SUBJECT: Black Ink Cartridge Seal

FROM: Copier Technical Support Section

VT3500  
Ges 5375/Rex 1280  
NSA CP375

SUBJECT: ROM Change  
( B jam with A4/LT drum/Jam detection in Skip Feed mode )

**OLD**

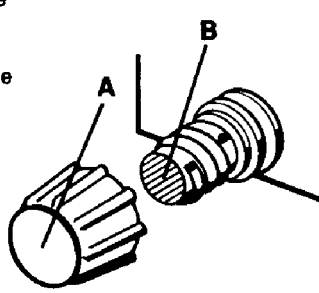
To increase ink production, the transparent seal will be removed from the exit of the black ink cartridge (500cc and 800cc ink). For the color inks, the transparent seal remains because the color inks are more fluid than the black ink. Due to this change, the instructions printed on the black ink cartridge will be changed as shown below.

**Handling Instructions**  
Remove the Cap A from a new cartridge of ink. Do not remove the Seal B. Set ink cartridge.

**Handling Instructions**  
■Set the ink in the machine immediately after the cap is removed to prevent entry of air.

### Modified ROM Program ( Flow Chart B )

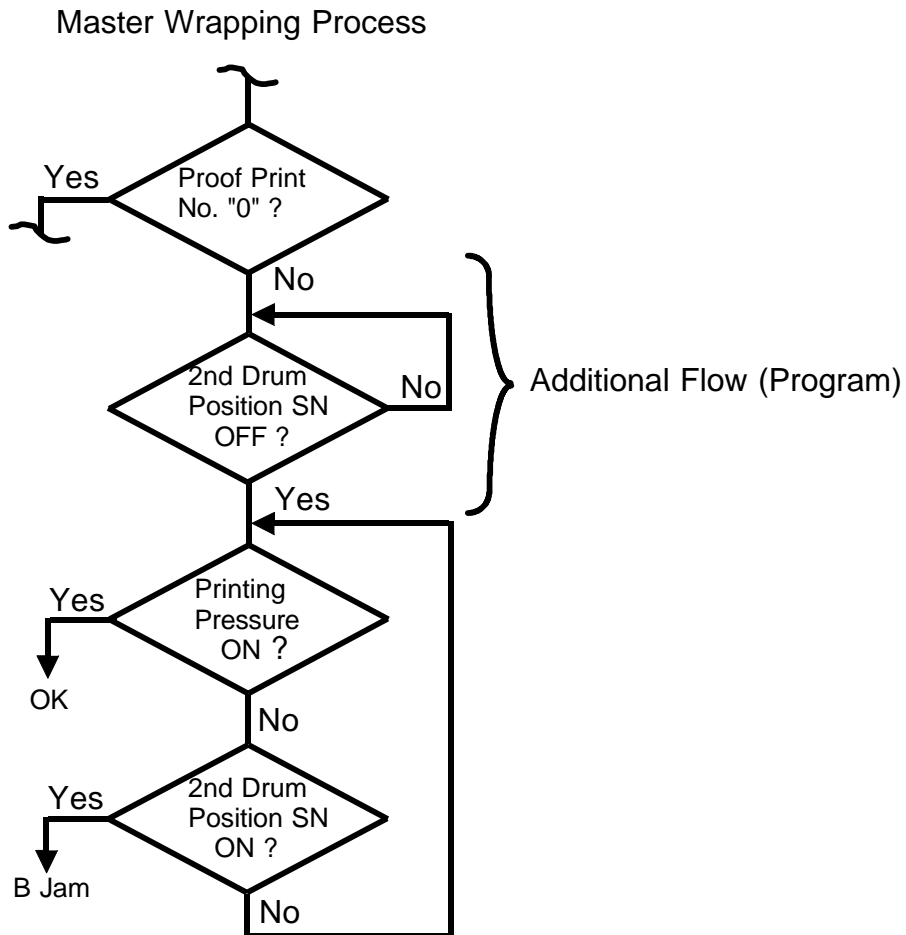
On the A3 drum, the paper feed solenoid turns on when the master making process is completed. However, this ON timing is too early for the A4/LT drum. Therefore, on the A4/LT drum, the paper feed solenoid turns on when the 2nd drum position sensor turns on. ( Normally, the 2nd drum position sensor turns on while the cutter returns to the home position. Then, the process proceeds to the master wrapping process.) But, if the drum rotation is delayed due to an overload, a paper jam is detected during the master wrapping process because the 2nd drum position sensor ON timing is delayed. Normally, the 2nd drum position sensor should be OFF at this time. (See the attached flow chart A.)

To prevent the above problem, the ROM program relating to the master wrapping process has been modified. During master wrapping process, the paper misfeed is detected after the 2nd drum position sensor turns off. (See the attached flow chart B.)

SUBJECT: Paper Exit Pawl

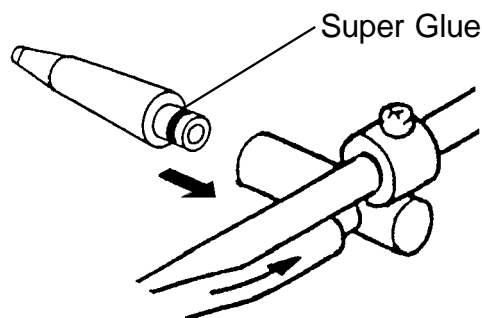
During the printing run, the paper exit pawl slightly comes off and it contacts the drum screen. This causes a black line on copies. In the worst case, the exit pawl contacts the master clamper and the clamper may be damaged.

1. Check whether the exit pawl comes off or not.
2. Make sure that the exit pawl does not come off by pulling it out with light force ( with fingers).
3. If it comes off, apply super glue one turn around the joint area and insert it as shown.

SUBJECT: Pressure On/Off Lever Breakage

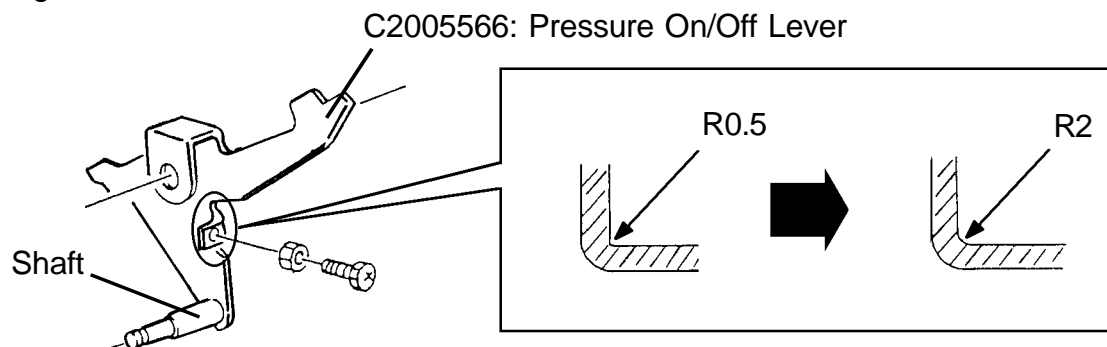
It was reported that the adjusting screw tab of the pressure on/off lever is sometimes broken.

To increase the durability of the lever, the angle has been rounded as shown in the illustration. This will reduce the stress on the adjusting screw tab. The new type lever has been applied since the May '92 production. The cut-in serial numbers are as follows:

**Note:** Although the part number (C200 5566) is still the same, the shaft on the lever is marked with white paint. All spare parts which have been delivered from our SPC since May '92 are the new type only. Please note that the old type lever can still be used for the other series models.

SUBJECT: Priort Ink Lot Number

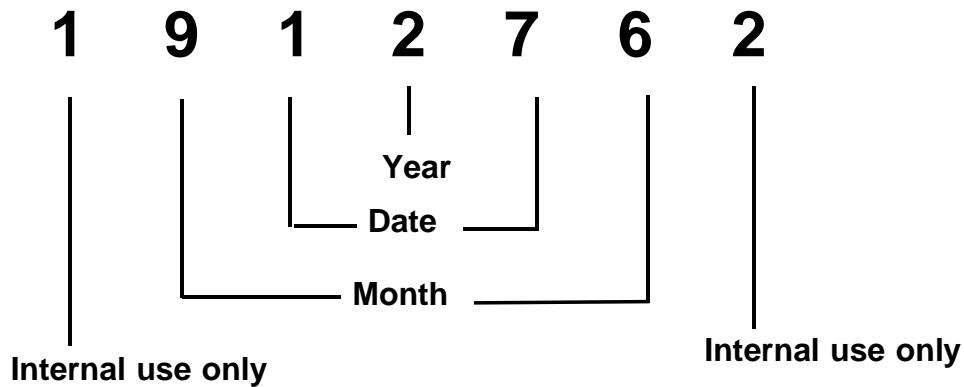
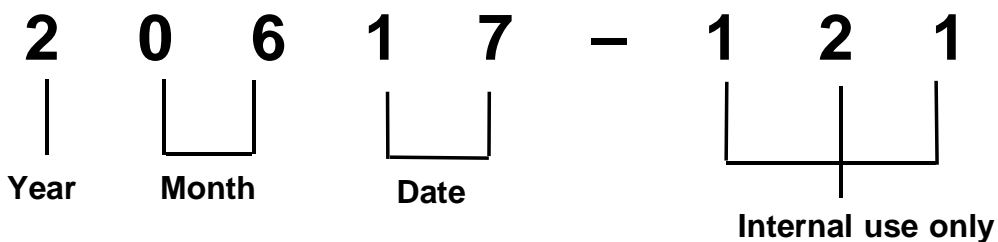
To clarify the ink production dating, the method of lot numbering has been changed as follows:

The above lot number means that the ink is produced on **June 17, '92**

SUBJECT: Damage of Optional A4 Drum

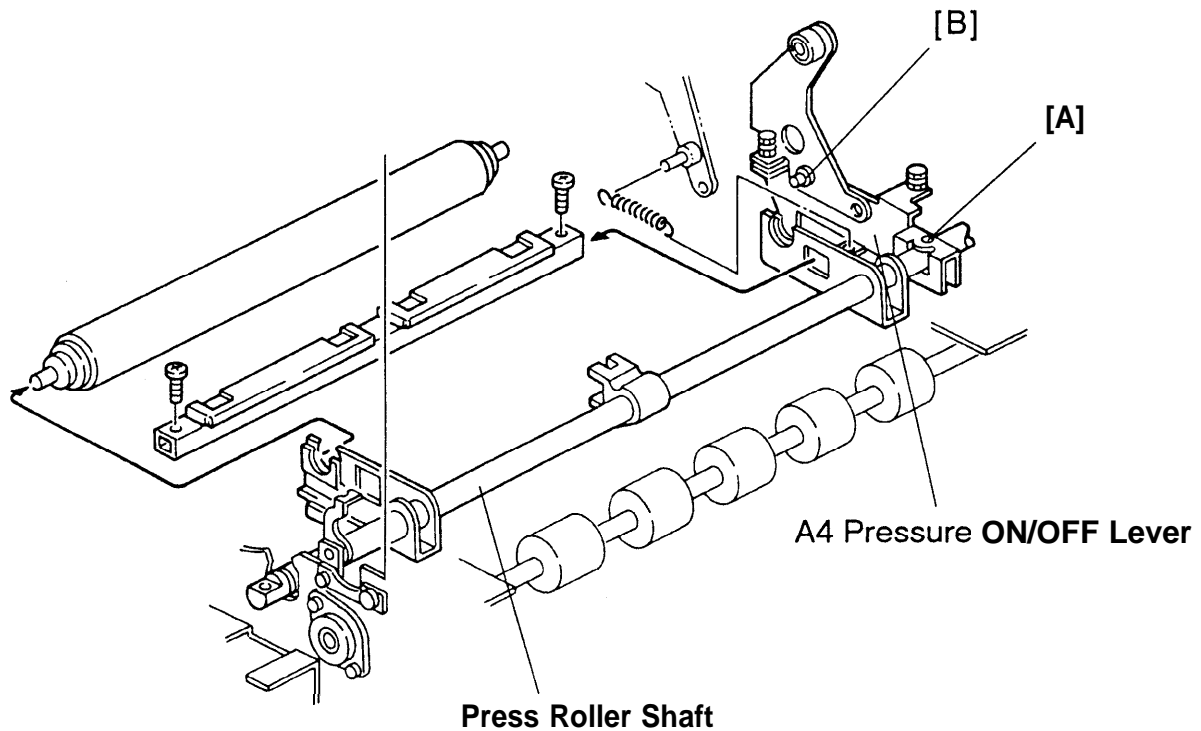
It was reported that the bolt (M5x14 hexagonal hole head bolt) that secures the A4 pressure on/off lever on the press roller shaft breaks. This will cause the exit pawl to hit the drum surface because the exit pawl drive cam is fixed with the A4 pressure on/off lever.

Since August 1992, the torque to tighten the bolt has been reduced and controlled to 40 to 50 kgfcm on the production line. In the past, it was around 100 kgfcm. It was found that there was possibility of the bolt breaking while using the optional A4 drum. The cut-in serial numbers are as follows:

1. Replace the bolt [A] with a new one (P/N: 05950140E).
2. Be sure that the bolt [B] (M4x6 hexagonal hole head bolt) is firmly tightened. If this is loose, the A4 pressure on/off lever does not operate properly.

SUBJECT: Ink Pump Improvement (For the NA2/NA3/NB2 Only)

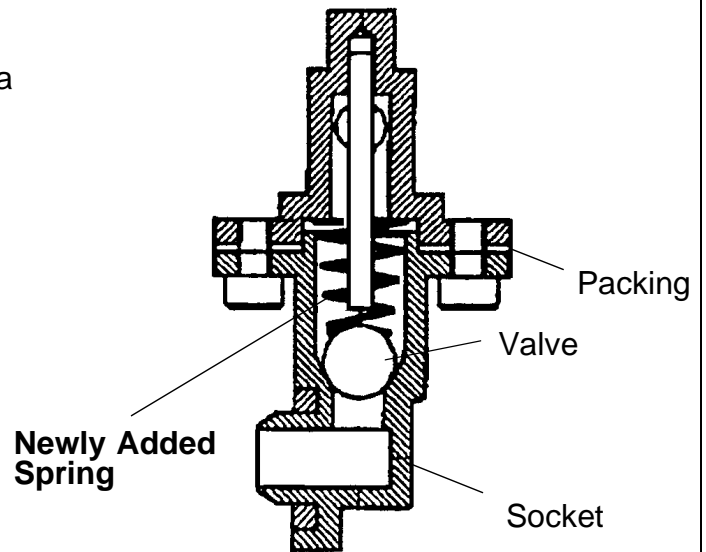
To ensure that all ink in the cartridge is supplied, a spring has been added inside the ink pump as shown to the right. The spring ensures that the small ball, which is used as a valve, is pushed back properly.

### SOLUTION IN THE FIELD

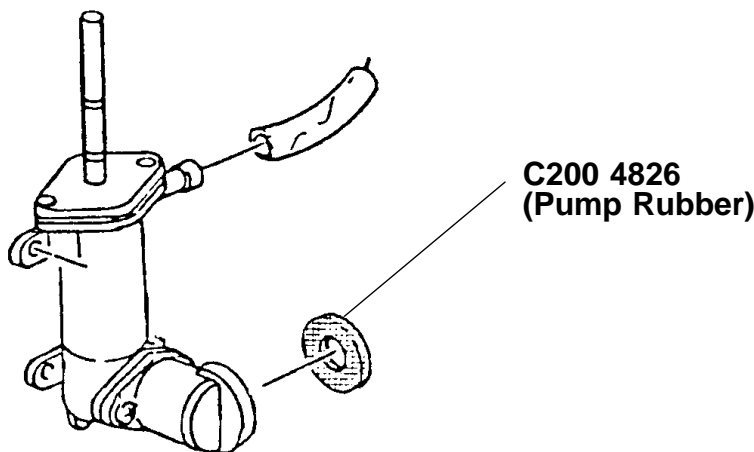
For the field machines, you can install the spring after removing the socket (with two screws). (It takes longer to replace the whole pump assembly.)

**CAUTION:** When you remove the socket, ink will leak. Be sure to place absorbent material to prevent ink from getting on the floor.

### Case 1:

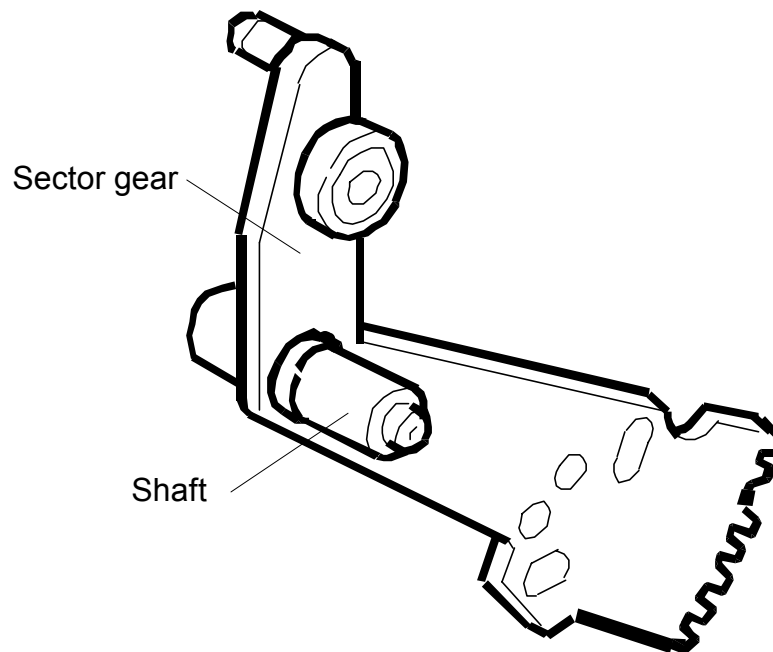
The sector gear [A] and the feed roller gear [B] ran out of lubricant. Because of this, the sector gear [A] will not be able to oscillate back and forth correctly.

**Model:** PRIPORT NA**Date:** 15-Apr-00**No:** R-C210-019**Case 2:**

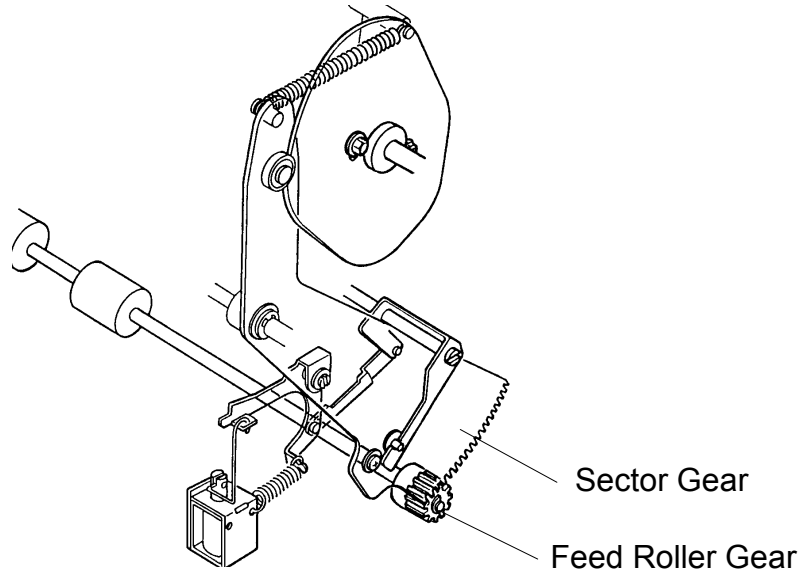
There is too much thrust play, and the sector gear is oscillating on the shaft.

Due to this, the sector gear will not be able to oscillate back and forth correctly. As a result, the sector gear does not move correctly on the 2nd feed roller gear and damages the teeth of the gear.

**Solution 2:**

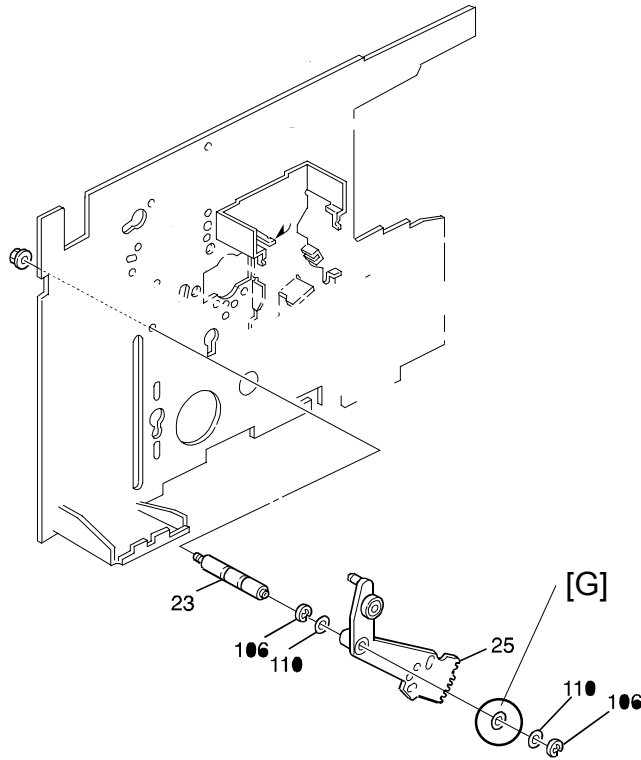
Add some spacers to remove the play.

Add 1 or 2 additional spacers [G] on the front side, as shown above.

Incorrect:

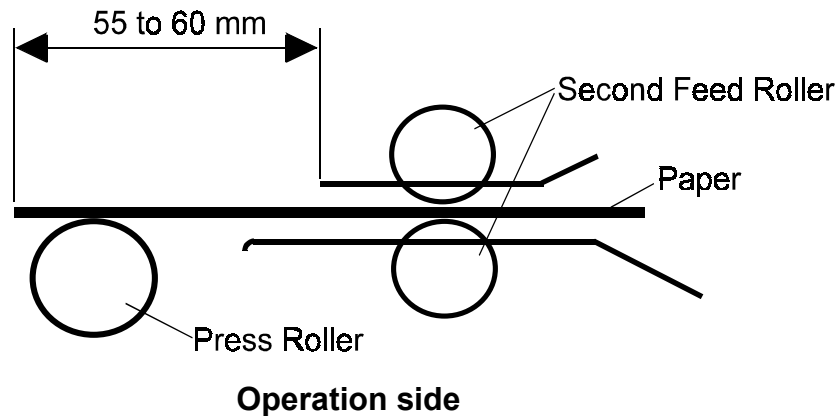
Please delete '**Pressure Timing Adjustment**' from your manual as follows. The pressure timing is common between the NA33 and NA6 models.

**NA33 service manual Page 5-74****● 9.5 Paper Exit Pawl Air Pump adjustment**

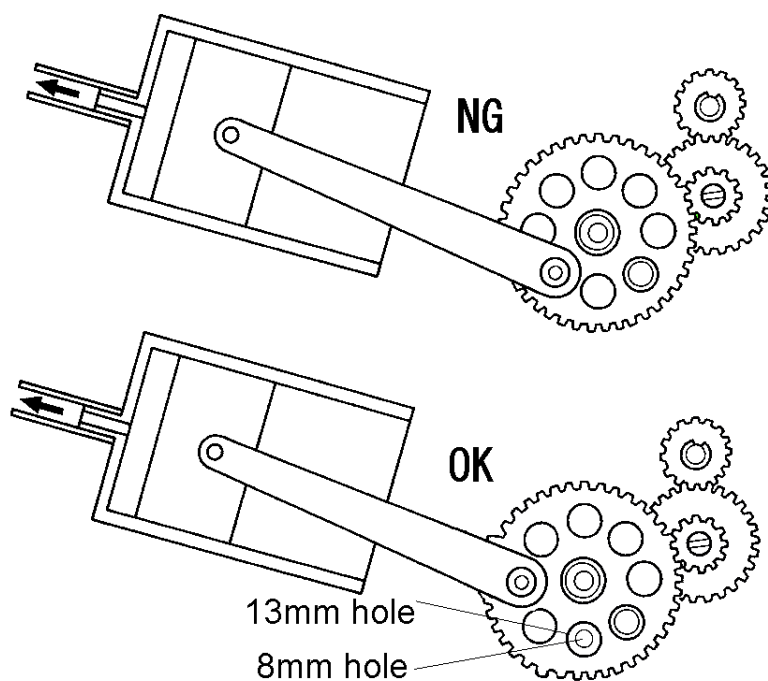
Please correct the procedure as follows. The 13 mm hole in the gear should be at the 6:00 position. (See below.)

1. Open the front door and remove the inner cover.
2. Press and hold down the 'Drum rotate' button until the drum reaches the home position.
3. Confirm that the 13 mm diameter hole in the gear and the 8 mm diameter hole in the side plate are lined up at the 6:00 position.
4. If the holes are not lined up, remove the E-rings and reposition the gear.
5. Rotate the drum to the home position and do step 3 again.

**NA33 service manual Page 5-29****● 6.2 Paper Table Height adjustment**

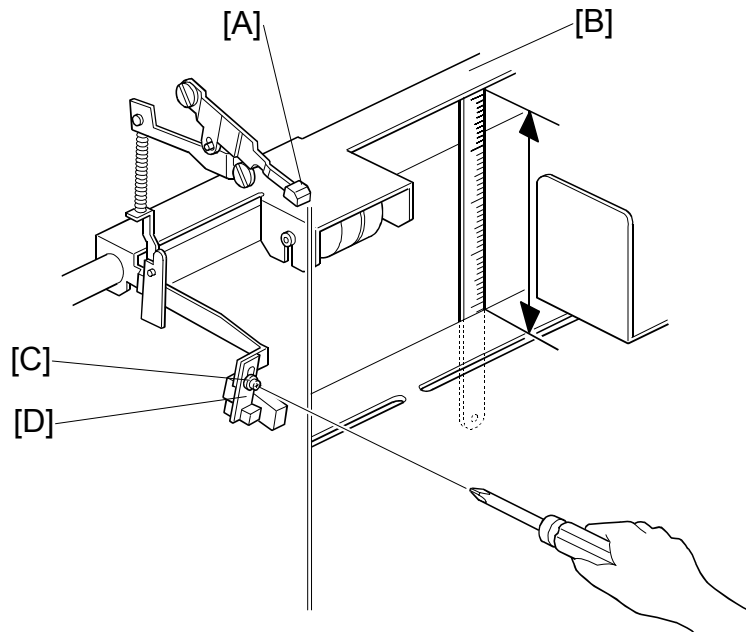
The table height can NOT be adjusted using the procedure on Page 5-29 (because there is no lower stay at the measuring point).

1. Set the paper feed pressure adjusting lever [A] to the upper position.
2. Remove the right cover of the machine (5 screws).
3. Turn on the main switch and access the SP mode.
4. Select output check mode (SP131) no.19, and press the Print start key to raise the table.
5. After the paper table stops, insert a scale into the slot in the paper table. Make sure that the distance between the feed roller stay [B] and the surface of the paper table is  $52 \pm 0.5$  mm.
6. If it is not, loosen the screw [C] and adjust the position of the actuator [D].
7. After adjusting, repeat step 5 by lowering the paper table (output No. 18) and raising the paper table (output No. 19) several times, checking the height each time.
